Contract #: 04-0120F4Cty: SF/ALA Rte: 80 PM: 13.2/13.9File #: 69.25B**QUALITY ASSURANCE -- NON-CONFORMANCE REPORT****Location:** Changxing Island, Shanghai, PRC**Report No:** NCR-000285**Prime Contractor:** American Bridge/Fluor Enterprises, a JV**Date:** 28-May-2009**Submitting Contractor:** Zhenhua Port Machinery Company, Ltd (ZPMC), Changxing Island**NCR #:** ZPMC-0259**Type of problem:**

Reference Description: Inadequate pre-heat on North Tower, Lift 2, Skin A Doubler Plate**Description of Non-Conformance:**

Subject: NCR No. ZPMC-0259

Job Name: SAS Superstructure

Draft of welding discontinuity:

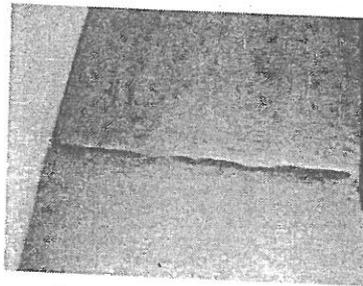
东塔第一吊装段AE角嵌补块与隔板对接缝背面衬垫由于长度不够、返修等原因造成了焊缝出现了多处不连续，需进行返修(注:18M,23M,33M,28M,43M,47.6M均有不同程度的损伤)，现已涂油漆.如图:
Several discontinuity was found at east tower first lifting corner AE flg plate and diaphragm butt weld, and needed to repair(remark: the base metal was gouged at 18m, 23m, 33m, 28m, 43m, 47.6m), and has finished paint, see the draft.

The backing was shorter than weld length, so it can't weld total weld caused discontinuity defects.

- 1、Grind the building-up area;
- 2、Preheat and weld passes temperature according to the approved WPS, it should be 2-3mm than the theory size;
- 3、Grind the weld area smoothly after repairing;
- 4、Perform 100%MT and 100%UT to the repair area.

Reference Description: Inadequate preheat on North Tower, Lift 3, Skin E doubler plate welds

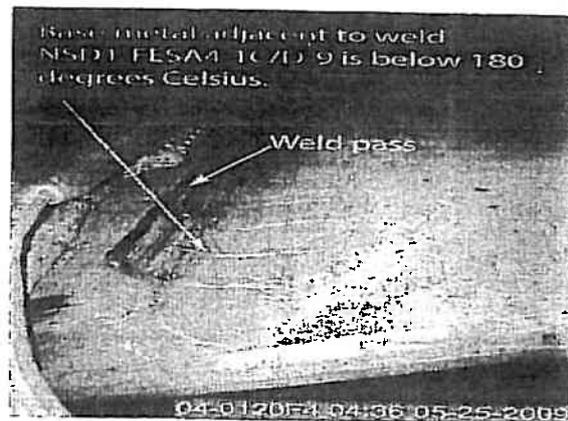
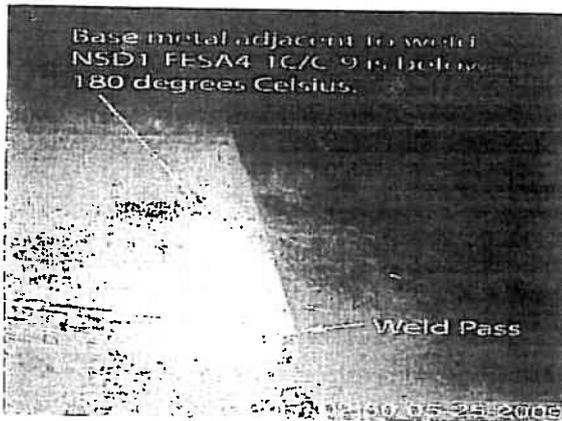
QA observed ZPMC personnel welding North Tower, Skin E, Lift 3 doubler plate welds NSD1-FESA3-1D/D-9, NSD1-FESA3-1DD-18 and NSD1-FESA3-1C/D-9 without the required base metal preheat. The photographs below indicate an unmelted 180 degree Celsius temperature indicating crayon adjacent to welds NSD1-FESA3-1C/D-9 and NSD1-FESA3-1D/D-9.

Propose a resolution for the identified non-conformance including documentation that the welds placed are in compliance with the contract requirements. In addition to the material/workmanship non-conformance, propose a resolution that addresses the failure of Quality Control to identify the lack of preheat of the base material. Provide documentation of the steps taken by the Quality Control Manager to prevent future occurrences.

Inadequate pre-heat on North Tower, Lift 2, Skin A Doubler Plate

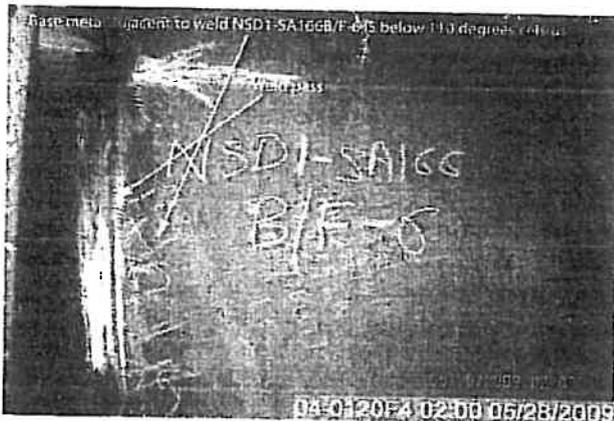
QA observed ZPMC personnel welding North Tower, Lift 2, Skin A doubler plate weld NSD1-SA166B/F-6 without preheating the weld and adjacent base material.

Welding procedure WPS-B-T-4332-TC-P6-F requires a minimum base material preheat temperature of 180 degrees Celsius.

The response is acceptable, but the Non-Conformance is not closed.

Please provide documentation of the weld repairs that were performed and that the repairs were acceptable. The Department will review the Contractor's proposal to close Non-Conformance ZPMC-0259 at that time.

The Non-Destructive Testing (NDT) for these welds should be at least 72 hours after welding to ensure that there are no delayed cracks from any possible hydrogen contamination.

For NCR ZPMC-0259 which was issued for lack of sufficient preheat, please provide documentation of the weld repairs that were performed and that the repairs were acceptable. The Non-Destructive Testing (NDT) for this weld should be at least 72 hours after welding to ensure that there are no delayed cracks from any possible hydrogen contamination.

The proposed resolution is acceptable. The weld in question has been accepted by VT and MT as shown in the attached documents, and the MT testing was done at least 72 hours after welding. The Department concurs that Non-Conformance ZPMC-0259 is closed.
